Explanatory Document to the second amendment of the Intraday Capacity Calculation Methodology of the Core Capacity Calculation Region

in accordance with article 20ff. of the Commission Regulation (EU) 2015/1222 of 24th July 2015 establishing a guideline on capacity allocation and congestion management

Public Consultation

Figure 2: High-level Flowchart Core FB IDCC – Target solution

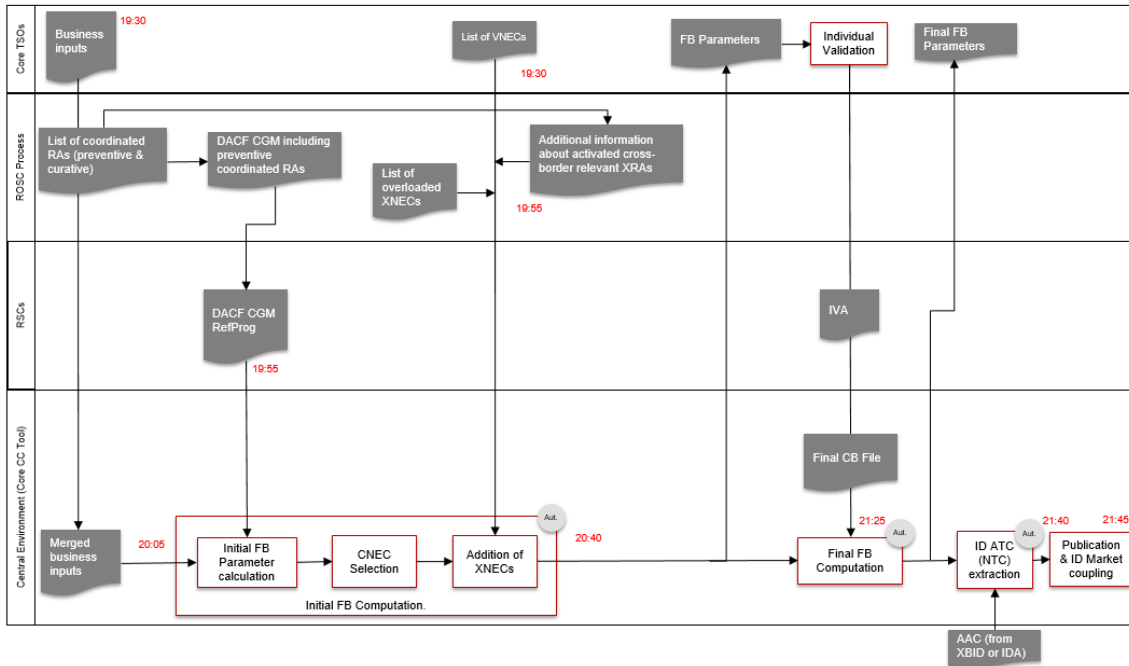
The target of Core IDCC process is to include at the beginning of IDCC process the full set of “Agreed RAs” if available, or the “Proposed RA” if the coordinated RAs are not available. The high-level business process of the target Core IDCC process, with current timing assumptions¹, is depicted below.

Technically, the major changes compared to the business process before amendment are:

- Skipping NRAO steps and discarding of MNECs since they are not used anymore in the process.
- Merging Initial and Intermediate FB computation
- Inclusion of preventive (in case not included in CGM) and curative RAs from the list of RAs provided by ROSC CROSA process (“Proposed” or Agreed” RAs) in the Merged CBCORA file of IDCC as an input of the initial FB computation.
- Inclusion of a DACF CGM version including Proposed or Agreed preventive (incl. redispatch) RAs from ROSC (CGMES format).
- Incorporate a subset of XNECs which are overloaded after the second regional security assessment (19:20 D-1) during the ROSC process in the IDCC as CNECs if cross-border redispatch or countertrading has been applied (application of Art. 31 of Core ROSC CCM).

Figure 3: Sub-process of inclusion of XNEC from DA CROSA process in IDCC

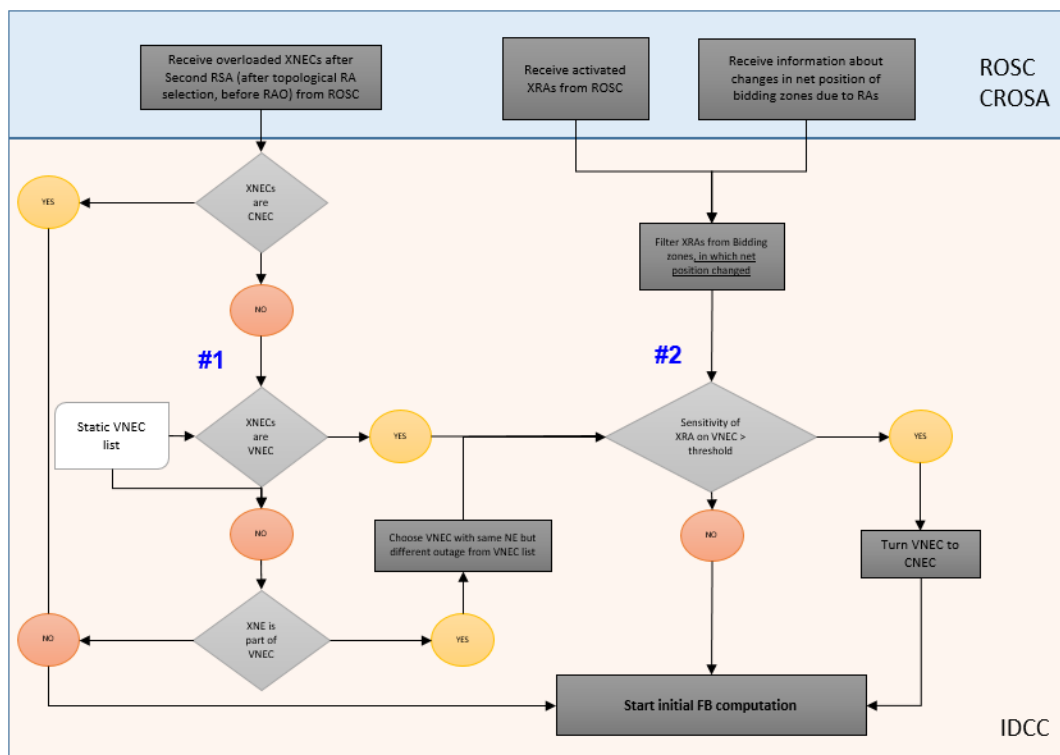
Article 31 of the Core ROSC CCM allows TSOs to prevent that XRAs coordinated during the ROSC process which include a cross-border schedule free up additional ID capacity. An additional step is therefore proposed with the intention of strictly applying Art. 31 of ROSC methodology by including a minimum subset of overloaded XNECs from ROSC as additional CNECs in the IDCC if cross-border redispatch or countertrading has been applied. Their inclusion shall prevent the market from counteracting applied XRAs. It is important to highlight that the respective overloaded XNECs are detected as overloaded by CROSA prior to the application of Remedial Actions. These overloads are to be addressed by the CROSA and since a CGM including preventive Remedial Actions is considered at the start of the IDCC process, the XNECs shouldn't be overloaded anymore.

In details, the principle of the process is based on a 2-step filtering approach of overloaded XNECs from ROSC DA CROSA process that is depicted in the figure below:

1. Overloaded XNECs must be part of a static VNEC list defined in IDCC process
 - If an overloaded XNEC is not part of pre-defined VNEC list, this XNEC is ignored by IDCC process.
2. Overloaded XNECs must have a minimum sensitivity compared to any cross-border redispatch / countertrading activated in CROSA RAO
 - Depending whether this sensitivity is over a certain threshold (to be agreed upon amongst Core NRA and Core TSOs²), the overloaded XNEC is

turned into an additional CNEC in IDCC after the “normal” CNEC selection process. The RAM of such additional CNEC is capped up to zero to prevent any negative capacity that would go beyond the objective of Art. 31 of ROSC methodology.

- Such approach aims to comply with Art. 31(3a) of ROSC methodology. The “effect of activated XRAs on operational security” is assessed by computing the sensitivity of such activated XRAs from CROSA RAO on the overloaded XNEC. For the situation with a high sensitivity, the addition of overloaded XNEC as a CNEC in IDCC enables to “prevent the netting of cross-border schedules which results from activated XRAs” and “prevent that these schedules increase cross-zonal capacities in the direction in which additional trade could worsen operational security”.

Figure 4: High-level Flowchart Core FB IDCC – Interim solution

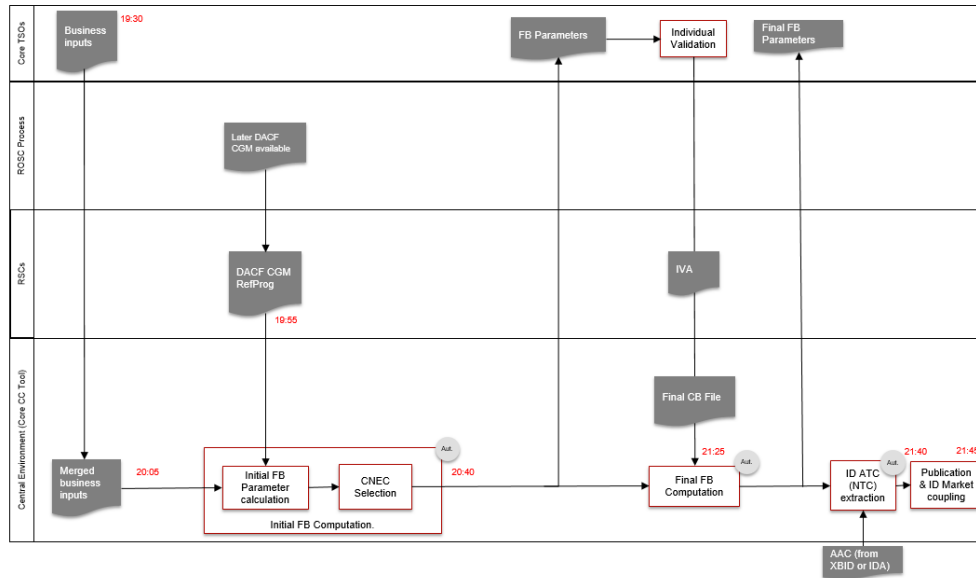
The interim solution consists in substituting the inputs that will be provided by ROSC v1 process (list of proposed / agreed RAs) by the similar outputs available from the ROSC ICS process in Core. The ROSC ICS (Improved Coordination Solution) substitutes the existing DACF CSA process in Core in 2021. Therefore, when considering the option of using existing DACF CGMs, this process should be followed. Consequently, it is

proposed to keep a very similar process as planned for the target solution as depicted below:

Compared to the target solution, the main limitations of the interim process based on alignment with ROSC ICS process are:

- Usage of an intermediate version of combined DACF CGM available before 19:55, with a partial coordination only. The full coordination at the Core level (last version of combined DACF CGM) is only available after the additional runs after DOPT are performed (~22:00). It is expected to have a more advanced level of coordination around 20:00 with the ROSC v1 process (end of coordination of the 1st regional run at the Core CCR level around 20:30). Nevertheless, since no operation experience with CROSA exists, this is only an estimation
- No inclusion of curative RAs since no list of RAs can be provided by ROSC ICS process.
- The common process to handle the XRA effect from ROSC CROSA (application of Art. 31 of ROSC CCM) is not included in the approach for the interim solution.

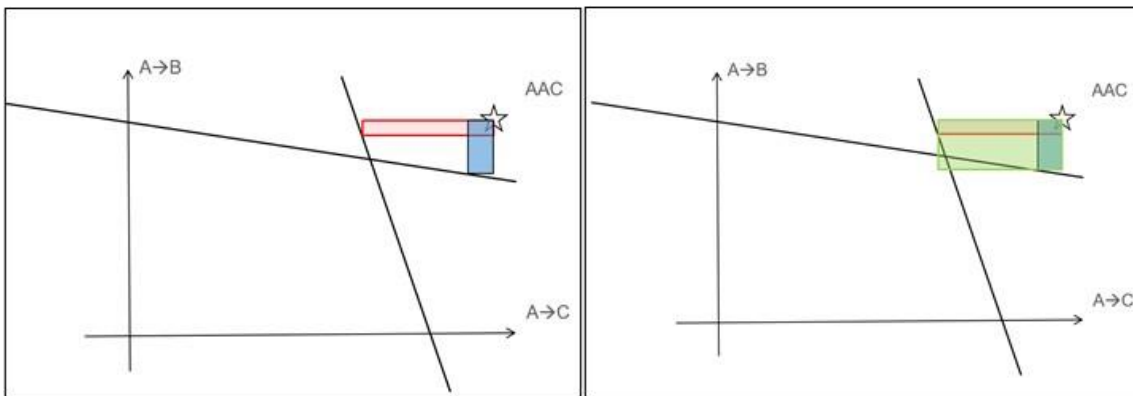
The Final FB IDCC Domain can contain CNECs with a negative RAM as no LTA or minRAM are applied in IDCC. Negative RAMs must be translated to negative ATCs for the allocation in XBID to ensure grid security by preventing netting. In case a trade is made in a relieving market direction, the market would not be allowed making trades that would go back in the critical direction until the negative ATC becomes positive again. For example if there is a negative ATC for the border direction $A \rightarrow B$ of 100 MW then 101 MW have to be allocated in the opposite direction $B \rightarrow A$ before an allocation in the burdening direction $A \rightarrow B$ is possible again. A negative ATC is not seen as a hard constraint and not imposing any cross-zonal trade. It is just preventing the netting effect in case there are trades in the direction towards the 'safe' capacity domain. For ID Auctions, a zero ATC will be provided instead of a negative ATC. Hence, there is no loss of socio-economic welfare, the IDCC process is only providing negative ATCs to XBID (continuous trading) to prevent that freed-up capacities in ID Auctions are taken back during continuous trading.

ID CCM Art. 21 foresees to share the negative RAM equally to all Core borders for ATC extraction as done for positive RAMs. The issue with the current ID ATC extraction method is that on distant Core borders a relative small negative RAM could lead to disproportionate negative ATCs. For example a CNEC in Western Europe with a negative RAM of -10 MW could lead to a negative ATC of -1000 MW on a border in Eastern Europe when its sensitivity is at 1% for this border. Those high negative ATCs would basically block this border direction for the ID market although the benefit from grid security perspective is very limited. Core TSOs propose to take PTDFs into account when distributing negative RAM to borders. A border with a PTDF of 10% would receive double the share of negative RAM of that CNEC compared to a border that has a PTDF of 5%. This in turn would limit the impact on distant borders. This approach minimizes the sum of all negative ATCs while increasing the negative RAMs on sensitive borders leading to increased grid security

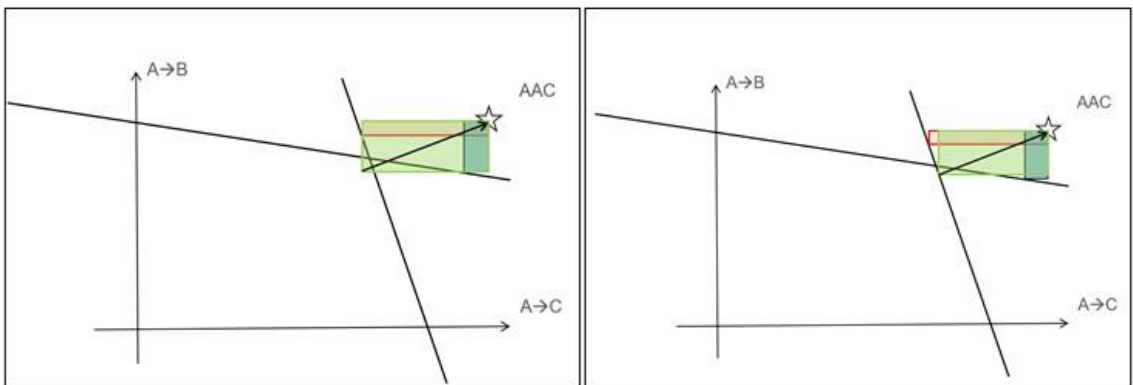
The second step aims at calculating the negative ATCs that result from the negative RAMs before curtailing them to zero. Only for this second step the sharing of RAMs shall be adapted to take PTDFs into account (instead of equal share over all borders). It will calculate negative ATCs for all borders for which a CNEC with negative RAM and positive PTDF exists. The idea of this approach is to keep the ratio of negative ATCs the same but only have as much negative ATCs as is needed to ensure that all negative RAMs can become zero or positive. A visual description of this approach follows:

Red and blue are negative ATCs of CNEC 1 and CNEC 2. The green area represents the resulting negative ATCs before scaling. As it is determined by the most negative ATCs it reaches inside the FB Domain.

During scaling, as visualized below, the green ATCs are reduced to just touch but not reach inside the safe FB Domain.
